Duke Power Company
Nuclear Design Methodology
Using
CASMO-3/SIMULATE-3P

DPC-NE-1004A
(Revision 1)

December 1997

NRC Safety Evaluation Report

Catawba Unit 1 HFP, ARO Boron Differences

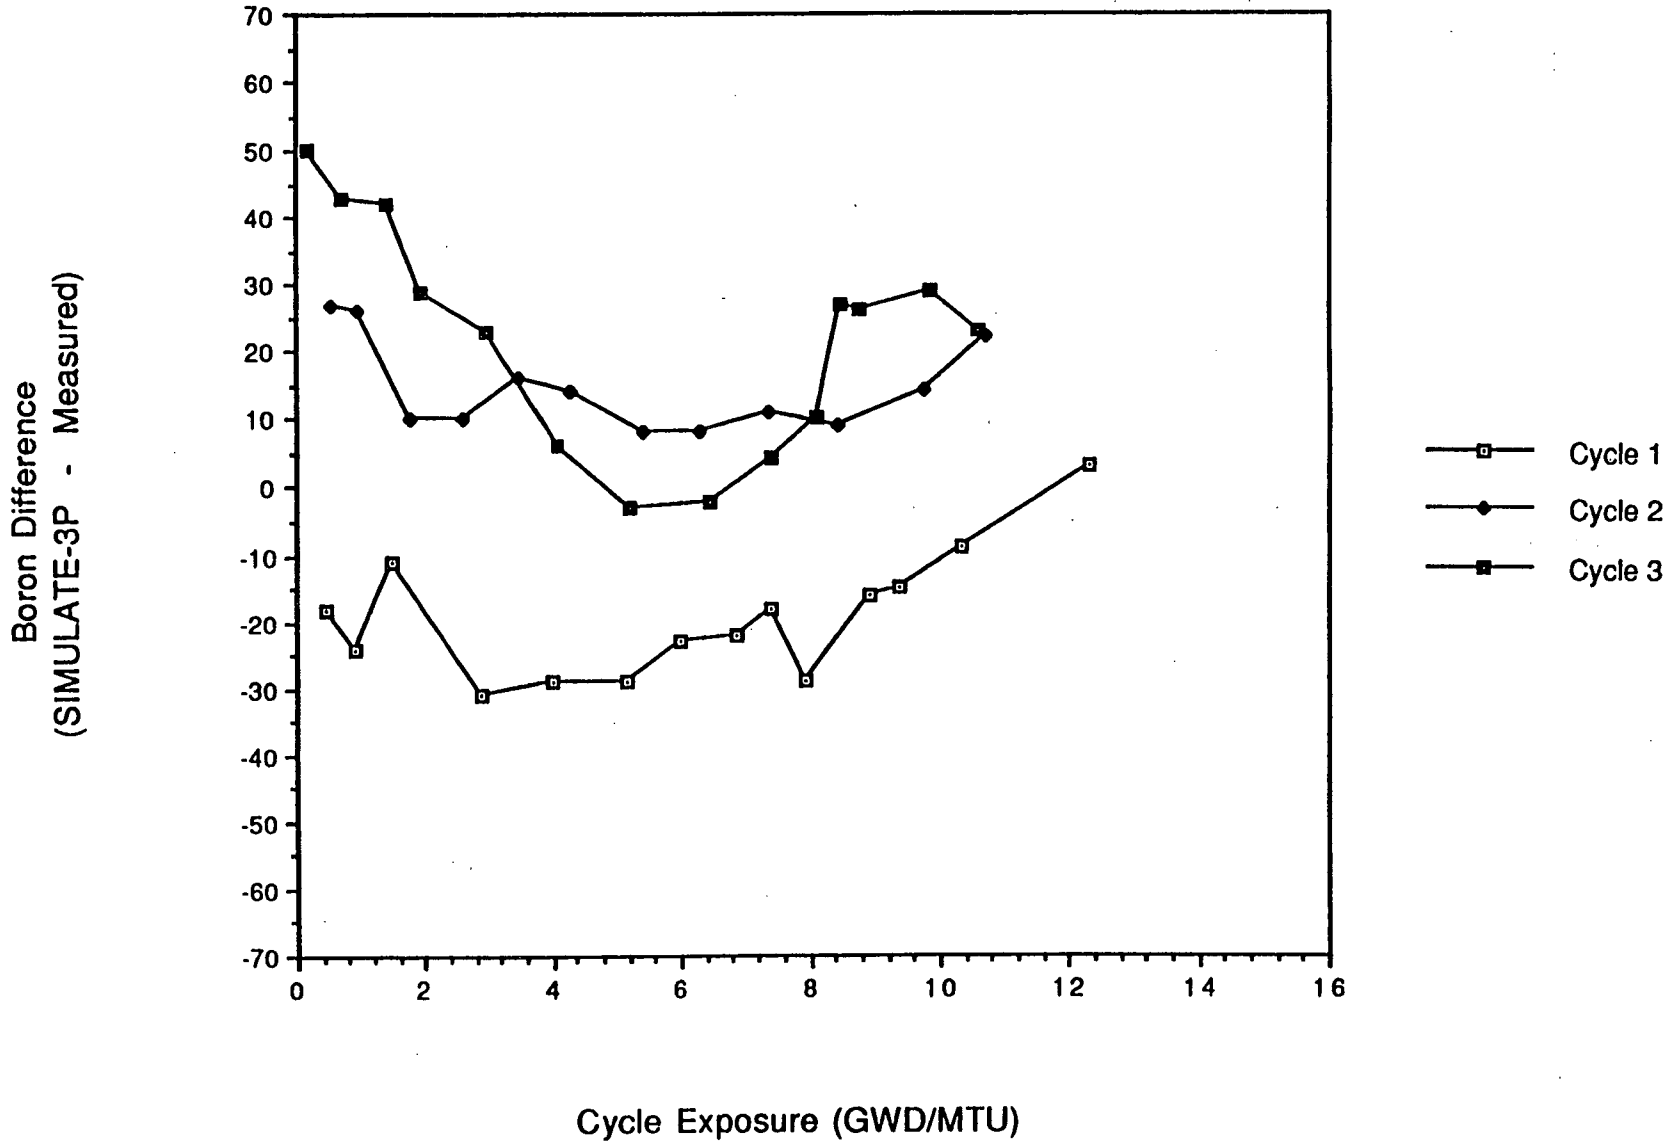
12. Question: Explain the trend with exposure of the boron difference for Catawba Unit 1, Cycles 1, 2, and 3, and Oconee Cycles 7 through 10. What is causing the significant boron overprediction in the early part of Catawba Unit 1, Cycle 3? Please explain.

Answer: There are a variety of explanations available for the noted boron differences. Among these are the uncertainties associated with the T_{ave} programs of the individual plants, the heat balance procedure for determining thermal power, the "as-built" Uranium and burnable poison loadings, variability of soluble boron enrichment and B_{10} depletion, and non-

Catawba Unit 2 HFP, ARO Boron Differences

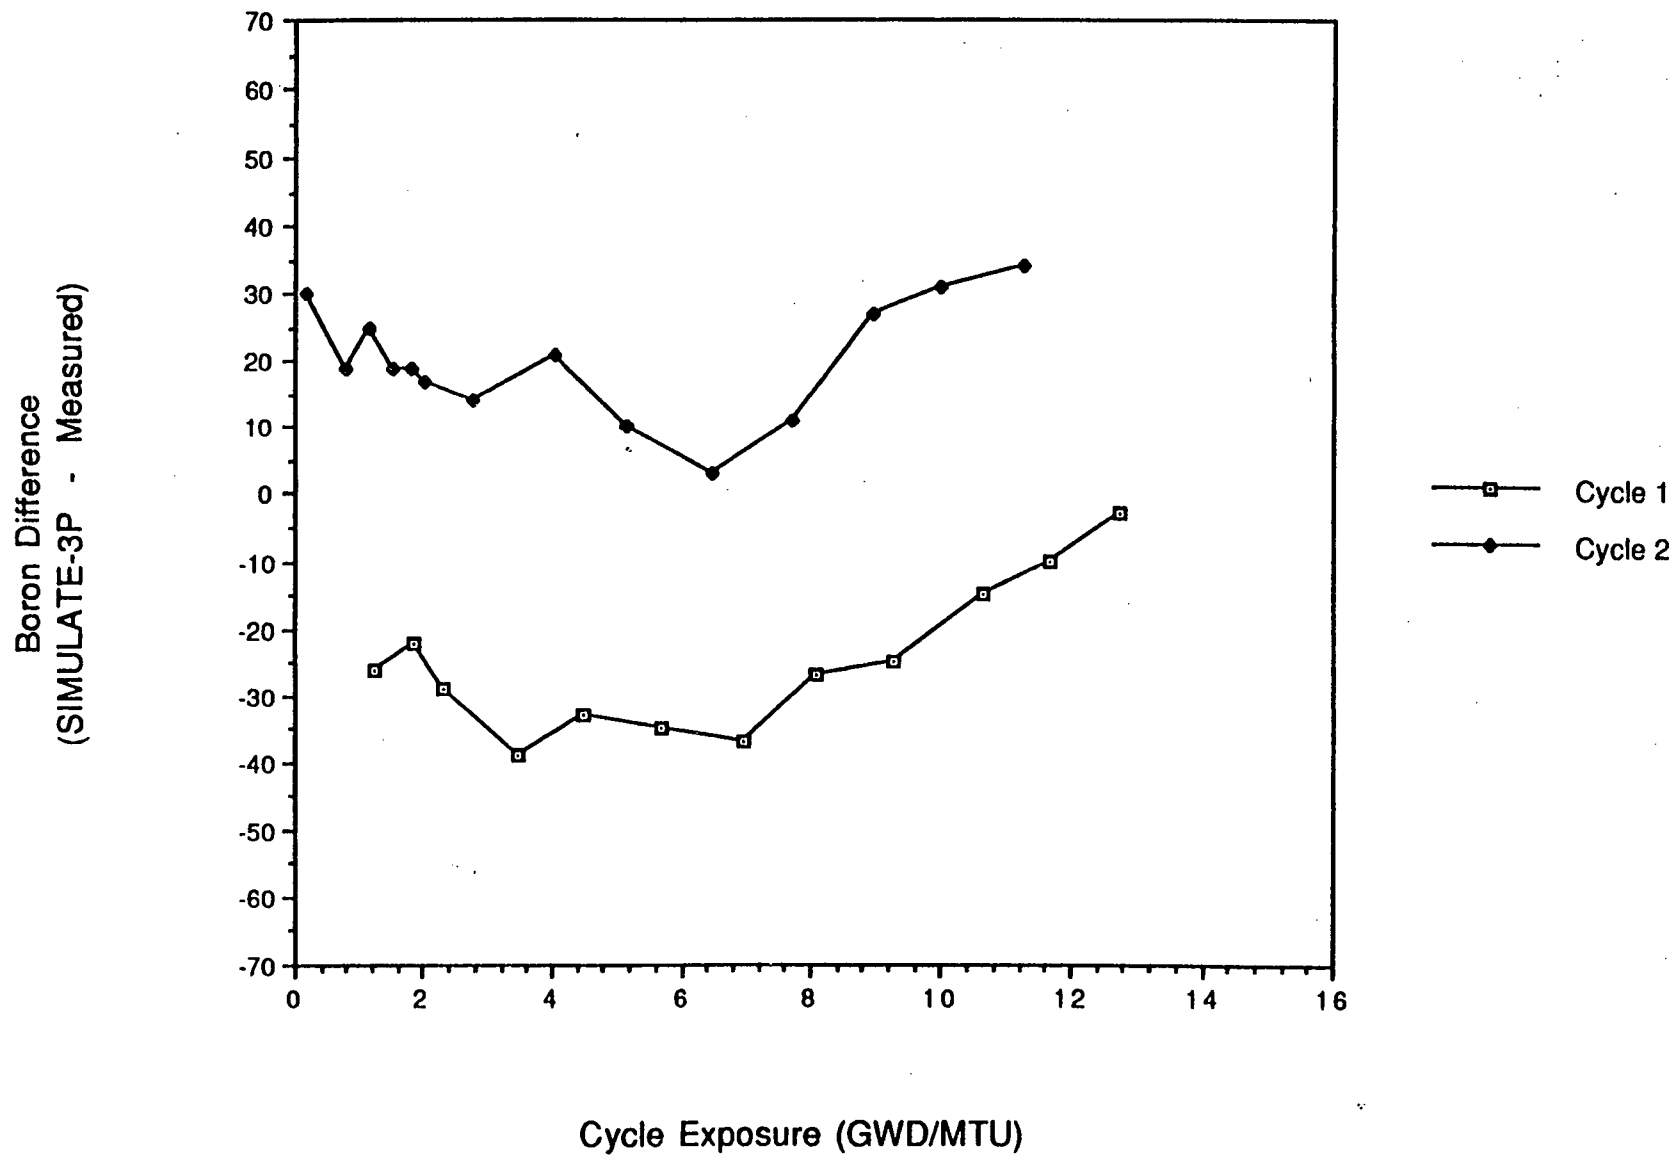
7. Question: Explain the observed SIMULATE-3P HFP critical boron concentration underpredictions for Catawba Unit 2, Cycle 3, Oconee Unit 2, Cycles 9 and 10 and overpredictions for the McGuire Unit 2, Cycles 2 through 5.

Answer: A general explanation of possible causes for mispredictions of critical boron concentrations has been provided in response to question #12. The results for Catawba Units 1 and 2 are very consistent and demonstrate consistent trends with McGuire Unit 2, with the initial cycle having a more negative result than the reload cycles. The McGuire Unit 2 results appear to have a bias as compared to the Catawba units with the initial cycle having a small overprediction for McGuire Unit 2 and a small underprediction for Catawba Units 1 and 2. Because the same fuel types and similar models are used for the McGuire and Catawba units, this bias may be attributed to plant specifics such as as-built plant and fuel differences. The results for Oconee Units 2 and 3 show very consistent trends in their underpredictions. The difference in trends between the B&W versus Westinghouse units is indicative of differences due to plant design, plant procedures, fuel designs, fuel vendors, etc. In the later cycles modelled for Oconee Units 2 and 3 there were some difficulties encountered with fouling of the Venturi tubes which are used in measuring the power level. This may account for the small changes observed in the Oconee Unit 2, Cycle 9 and 10 results. However, because the error in the measured power levels is unknown, the quantitative effect of the fouling cannot be determined. Please note that there were no HFP boron comparisons provided for Catawba Unit 2, Cycle 3 as the cycle had not yet completed operation when the benchmark calculations were

performed. Subsequent discussions with the NRC representative identified that the question should have referred to Catawba Unit 2, Cycle 1 instead of Cycle 3.

McGuire Unit 2 HFP, ARO Boron Differences

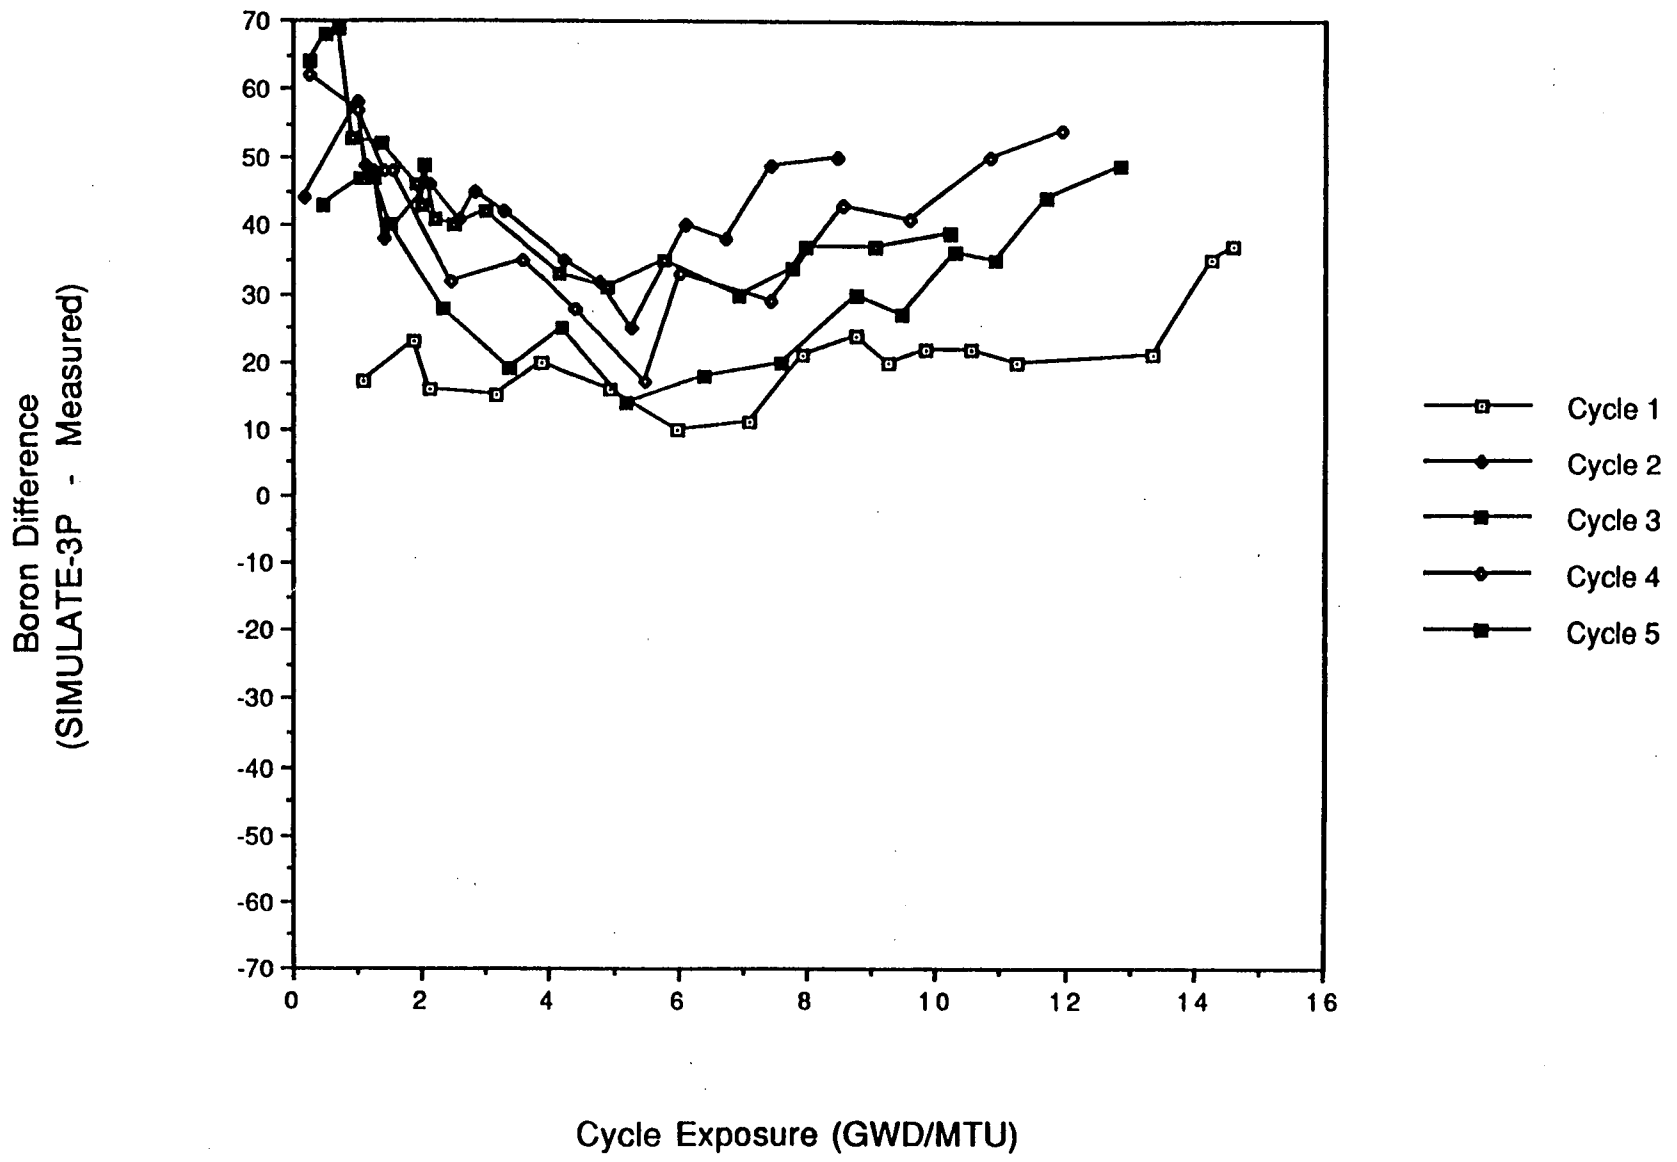
13. Question: There appears to be a systematic overprediction of the boron letdown in the early part of Cycles 3, 4, and 5 of McGuire Unit 2. Please explain.

Answer: One of the possible causes of these overpredictions lies in the specifications for the B₁₀ content of the boric acid. This is ordered to a specification of 19.9 ± 0.3 a/o B₁₀. The content assumed in the model is 19.83. This variability could account for 15-20 PPMB of the anomaly shown at the beginning of the mentioned cycles. Other possible causes for the overpredictions have been listed in the response to question #12.
